2.0 RESPONSE TO COMMENTS

Below are responses to comments received on the proposed project during the public review process. Two master responses have been prepared to respond to several comments received on water and 14 existing legal lots of record. Specific comment letters received have been addressed further below.

2.1 MASTER RESPONSES

Figure MR1-1
Geosyntec Study Area in Relationship to the Project Site

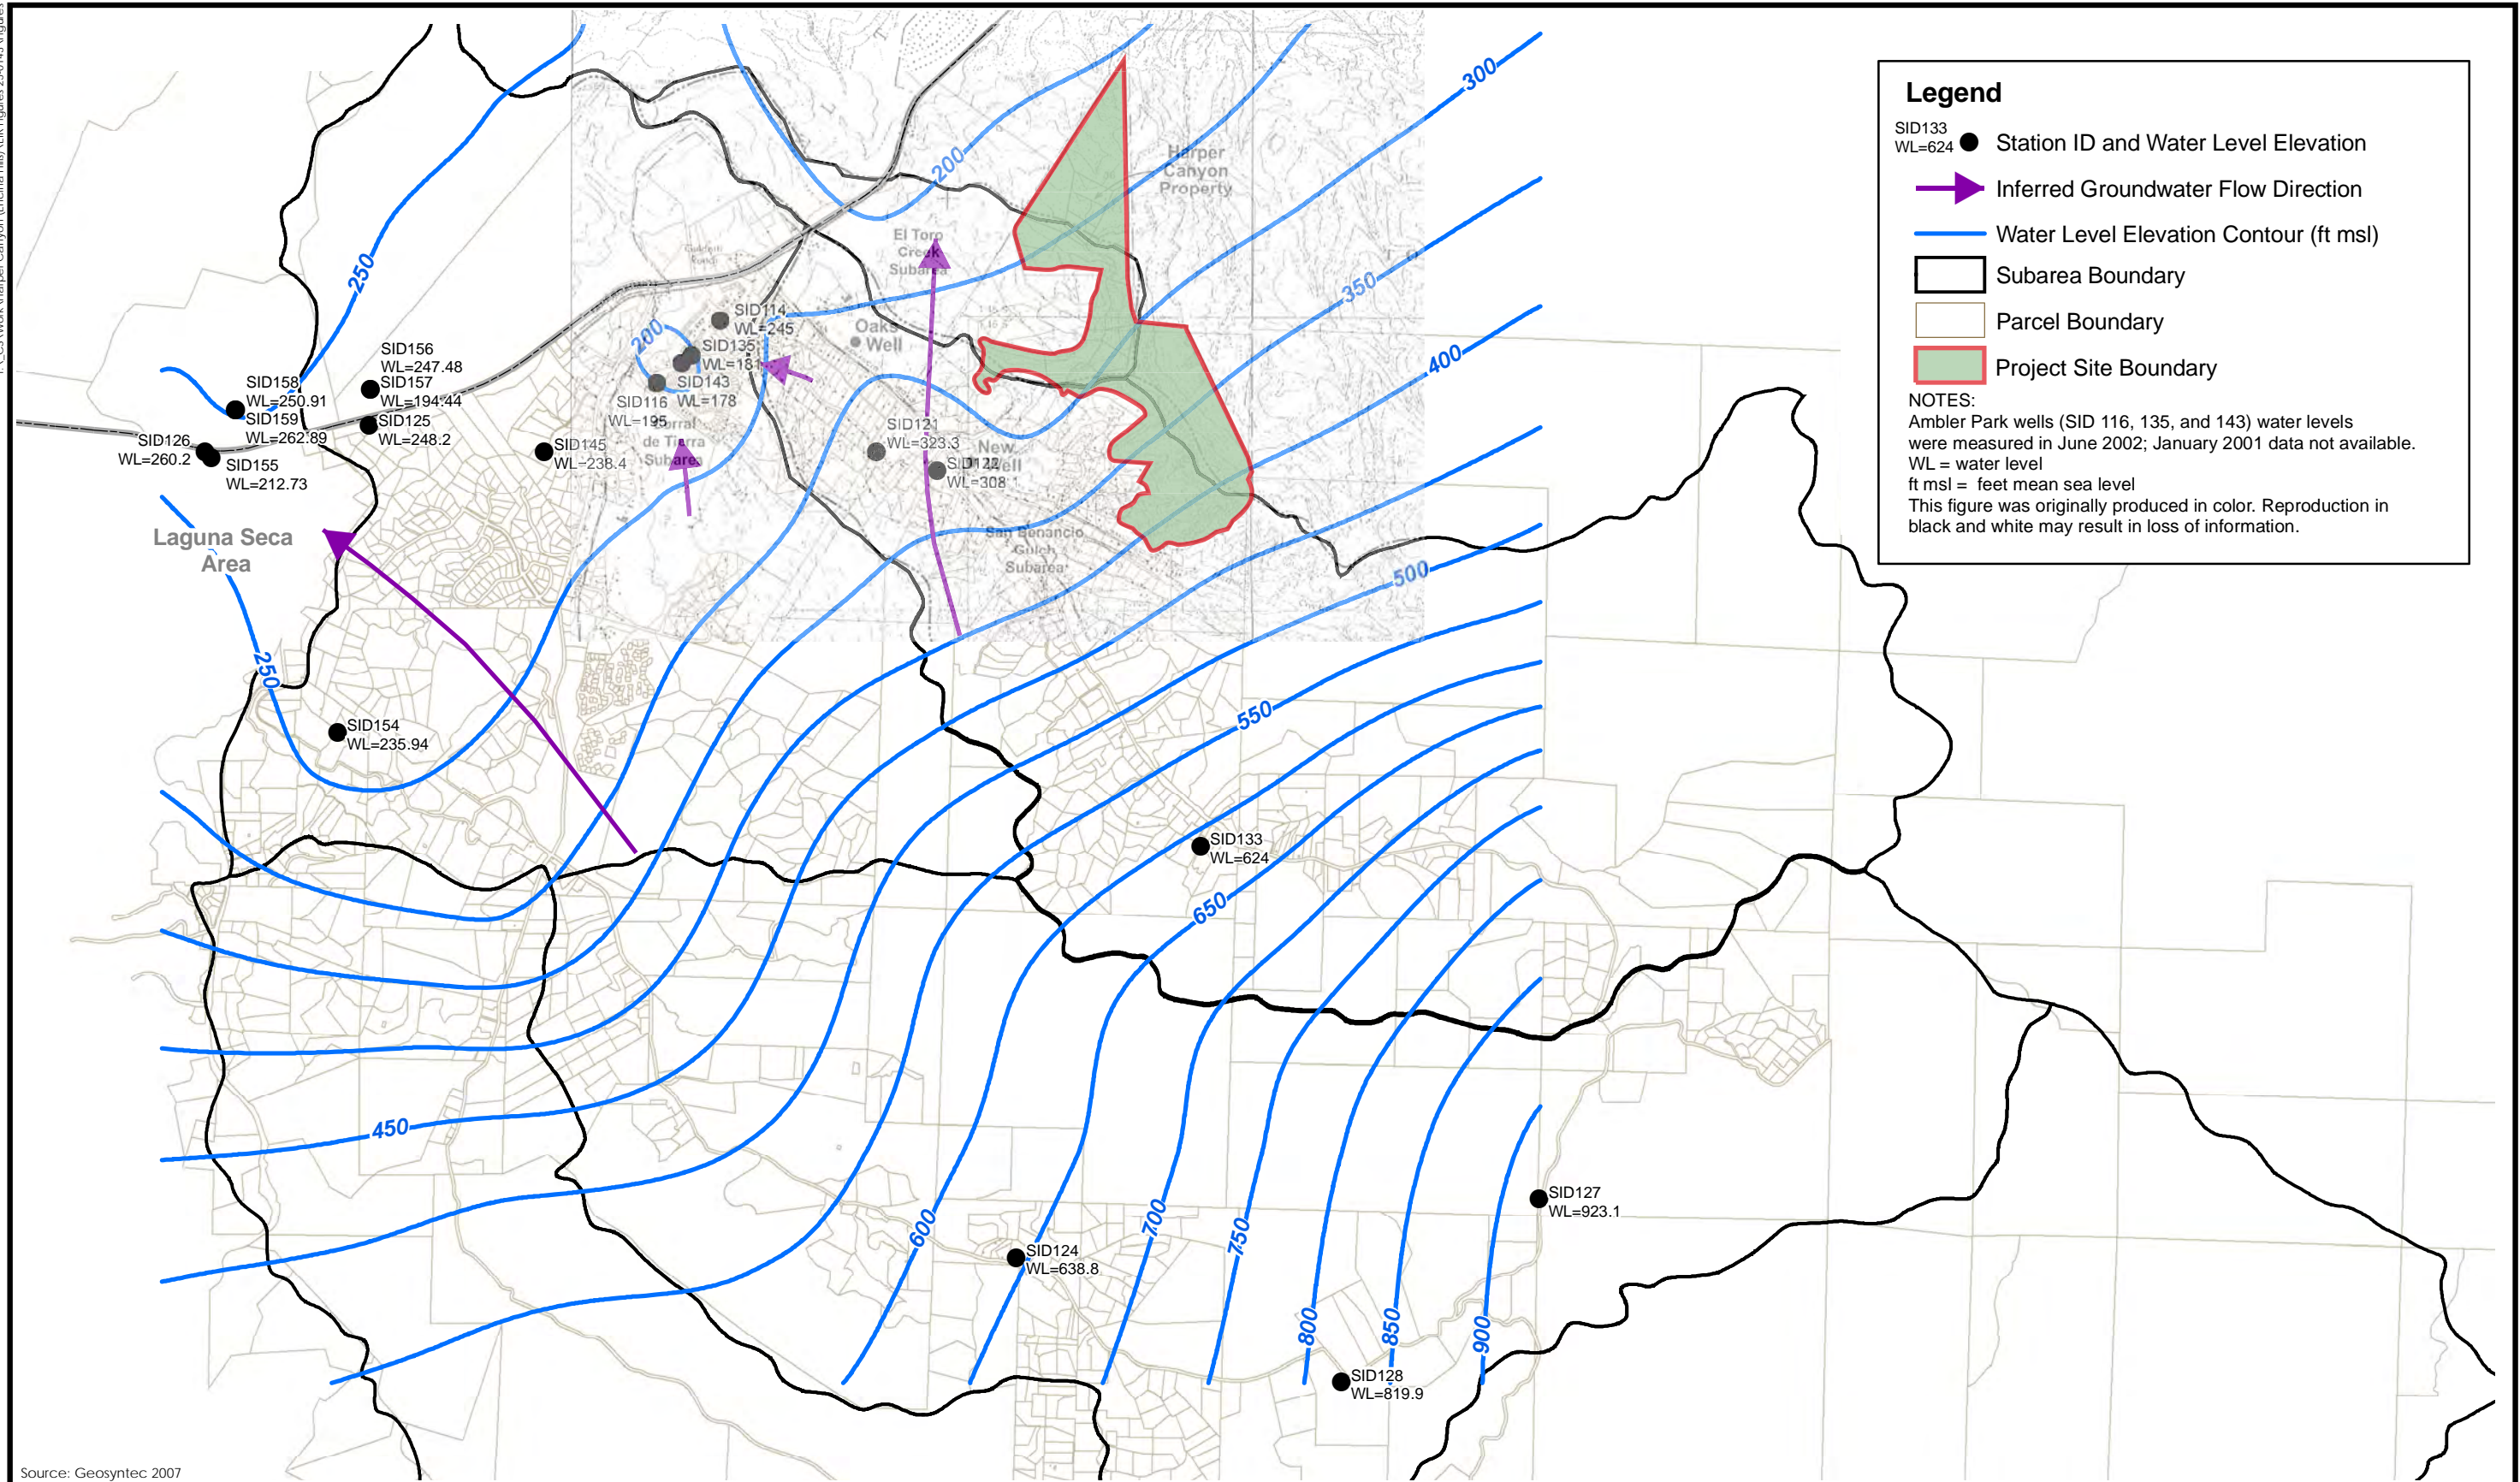
The primary objective of the Geosyntec study was to evaluate groundwater resource capacity in a portion of the Salinas Valley Groundwater Basin and to make recommendations regarding the extent of the B-8 zoning overlay, which with some exceptions, restricts development and/or intensification of land use where, due to various infrastructure constraints, the development or intensification is found to be detrimental to the health, safety and welfare (Monterey County Code Section 21.42.030). Although this report was prepared for MCWRA, it used a topography/watershed-based methodology to define its limits of study and did not take into account MCWRA’s Zone 2C boundaries or the recognized Corral de Tierra Area subbasin of the Salinas Valley Groundwater Basin. The relationship of the “Geosyntec Study Area” to the proposed project is illustrated in **Figure MR1-1**.

Figure MR1-2
Geosyntec Study Area Groundwater Flow

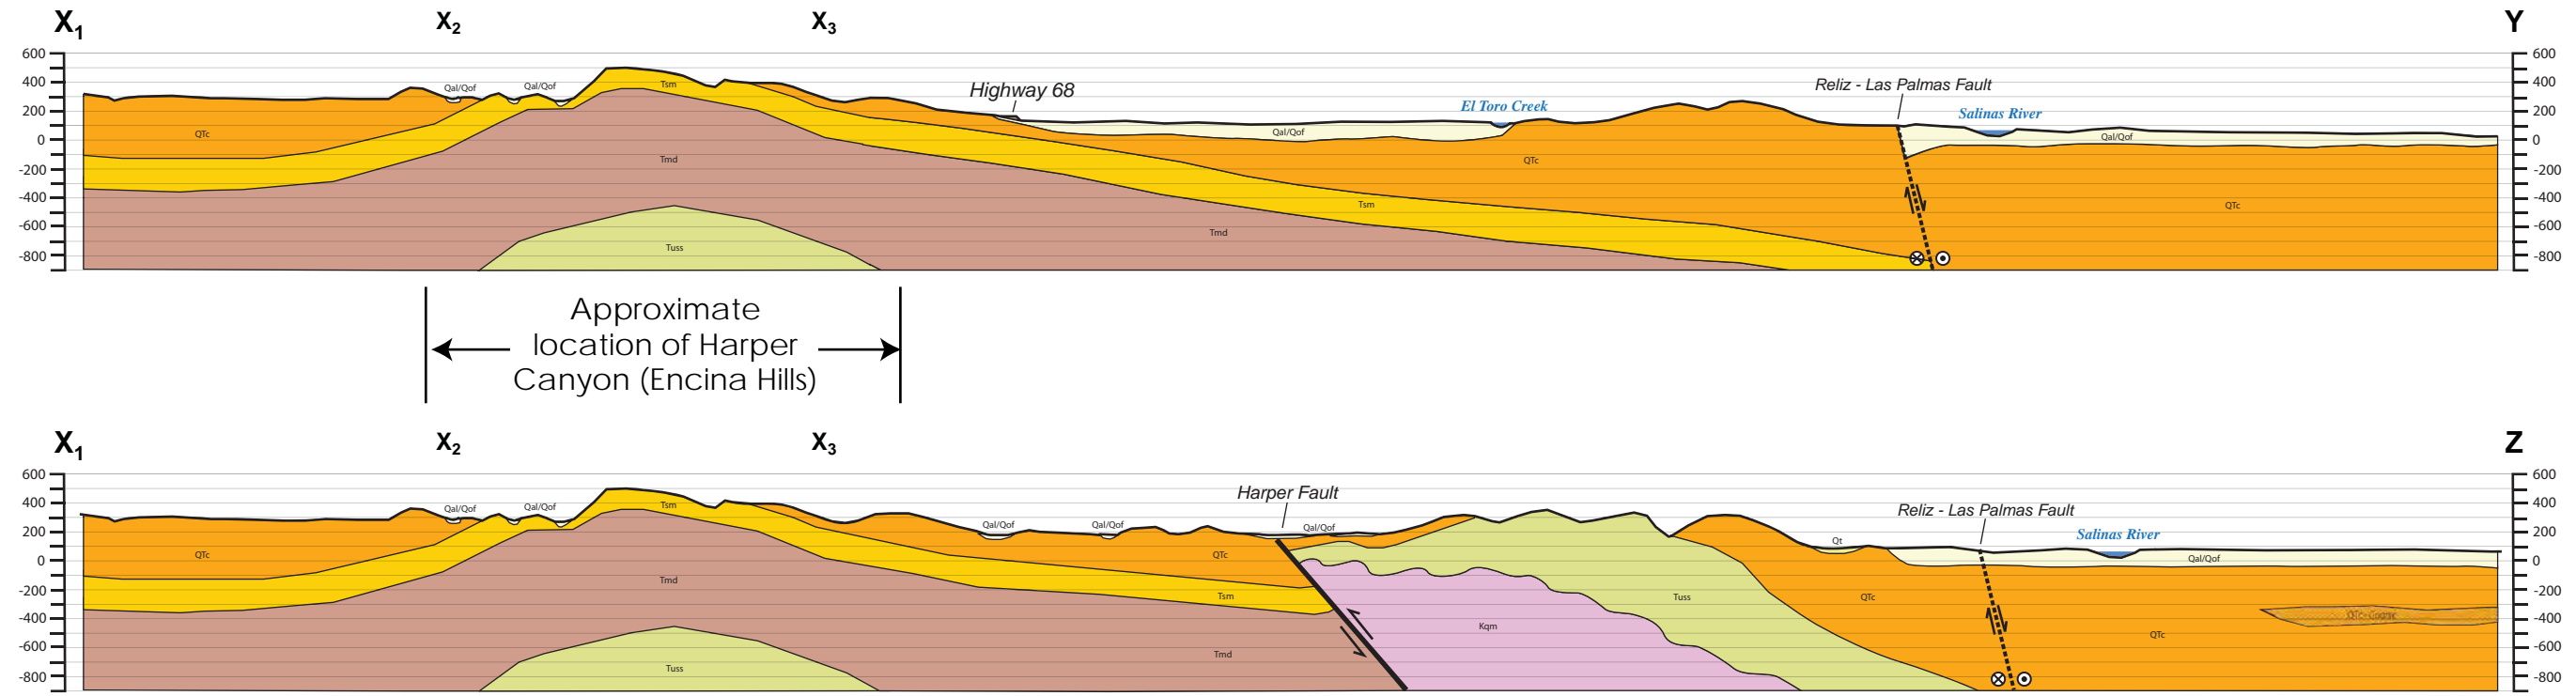
Water-bearing formations in the northeastern portion of the subbasin dip in a northeasterly direction toward the Salinas Valley as shown in **Figure MR1-2**. According to the supplemental geologic map and cross sections (MCWRA 2010), the Plio-Pleistocene Continental Deposits (QTc) (Paso Robles Formation) of the study area show that the hydraulic gradient under the El Toro Creek Valley/State Route 68 corridor is generally northeastward and contiguous with the Salinas Valley Groundwater Basin as shown in **Figure MR1-3**.

Figure MR2-1
14 Legal Lots of Record

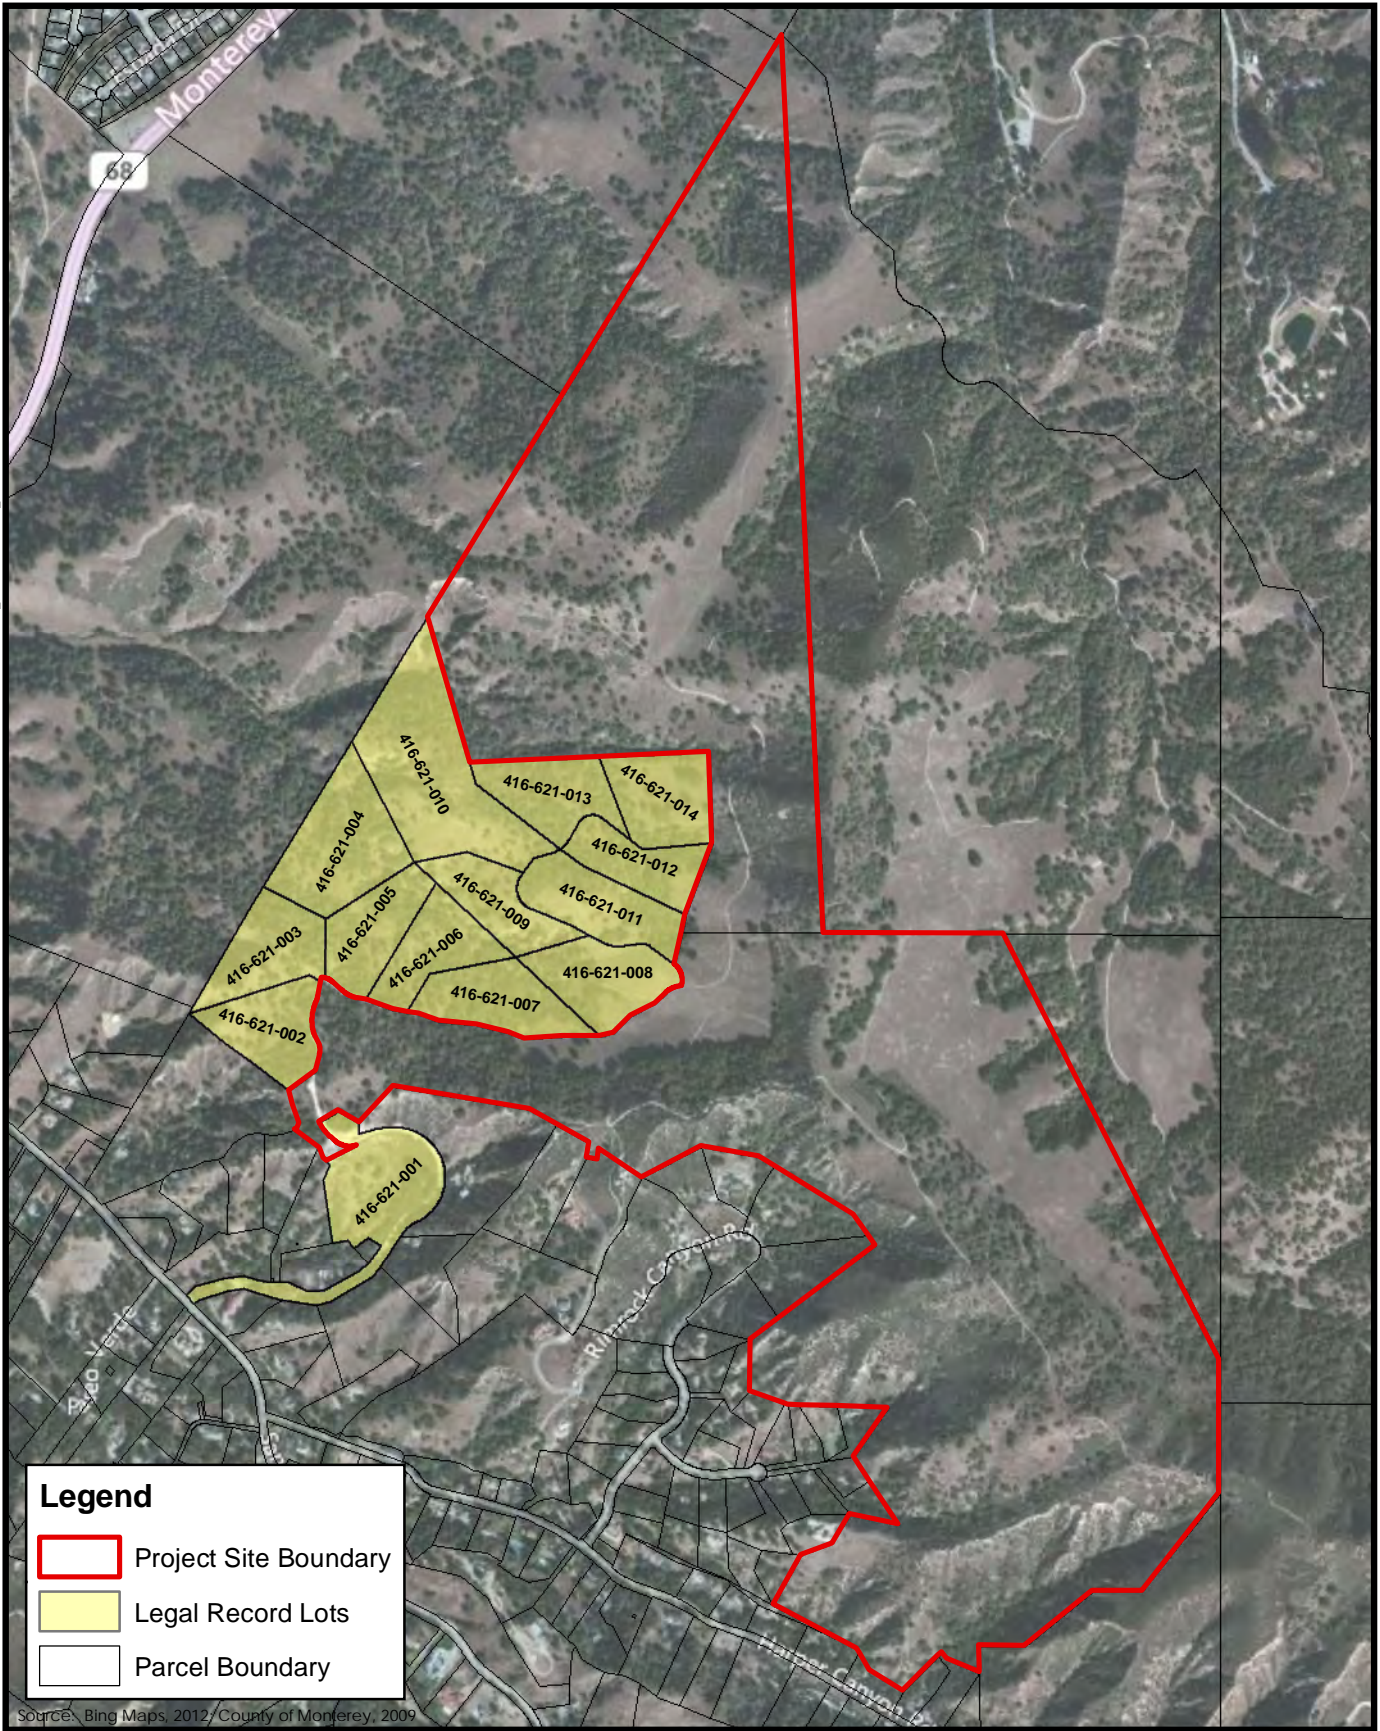
Several comments were received regarding the 14 existing lots of record (“Broccoli lots or parcels”) that are located adjacent to the project site (see **Figure MR2-1**). These 14 lots of record are owned by the project applicant, and were recorded in their current configuration in 1993. Fifteen lots on this property existed prior to 1993, but were adjusted via a major lot line adjustment approved by the County Subdivision and Minor Subdivision Committee. The adjustment resulted in the 14 lots plus one large remainder lot. That remainder lot of 343 acres is the area now proposed for the Harper Canyon/Encina Hills subdivision. The approval of the 1993 lot line adjustment contained several conditions of approval, and the approval was subject to the environmental and planning review procedures per the County’s process in place at the time. A negative declaration was prepared, considered and approved as part of the Committee’s action.

First, the 15 legal lots of record exist already. As such, the lots could be developed at any time if the attached conditions of approval are met and once proposed development (home sites) satisfy the County review and permit process. At any time the property owner could improve and extend Meyer Road and provide utility extensions to the existing 14 lots consistent with the terms of their approval. The development of the Broccoli lots is not dependent upon the approval of the Harper Canyon/Encina Hills Subdivision nor dependent upon access easements, as all lots in question are held in single ownership. The 1993 lot line adjustment was approved with the understanding that the lots would be accessed by an improved Meyer Road. The California Environmental Quality Act (CEQA) does not require re-analysis of a previously approved project unless ordered by a court of law following a successful challenge of the approval, or substantial changes are made to the project prior to development that triggers such analysis. No such conditions exist, no changes are being considered with respect to the 14 existing lots, and no specific development is proposed on the lots at this time.
